S E R V I C E N O T E

E1650A 75000 Series 90 Modular SONET/SDH Analyzer**Serial Numbers:**

**Disabling of ECLTRIG1 Line on E1405A or E1405B Command Module
due to incorrect pin connection on E1672A or E1674A Transport
Overhead Module.**

Figure 1

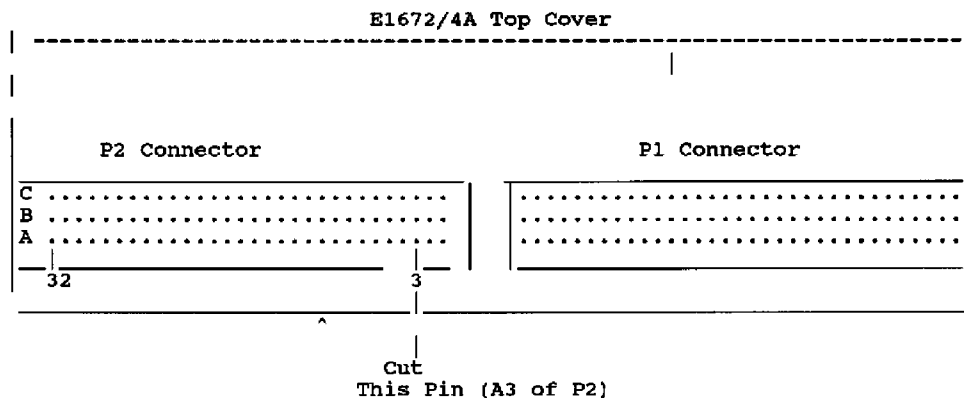
75000 Series 90 Modular Sonet/SDH Analyzers with Transport Overhead Modules with Serial numbers as shown above have a -5.2 volt supply incorrectly connected to pin A3 of the P2 connector of the E1672A and E1674A. This connects via the E1400B VXI Mainframe backplane, to the ECLTRG1 output of the E1405A/B. This causes the ECLTRG1 output to be rendered inoperative. This will not in any way affect the operation of the Series 90 but will affect any VXI modules which use the ECLTRG1 output and are used in the same mainframe as the Series 90.

Using the cutters recommended, clip pin A3 of the P2 connector on the E1672/4A module, off at the connector base so that it cannot make contact with the corresponding socket in the mainframe backplane. Be sure to capture the off cut of the pin to ensure that it cannot cause damage.

Refer to figure 1 below to locate the correct pin.

Cut pin A3 of P2 with due care. Be careful not to bend adjacent pins
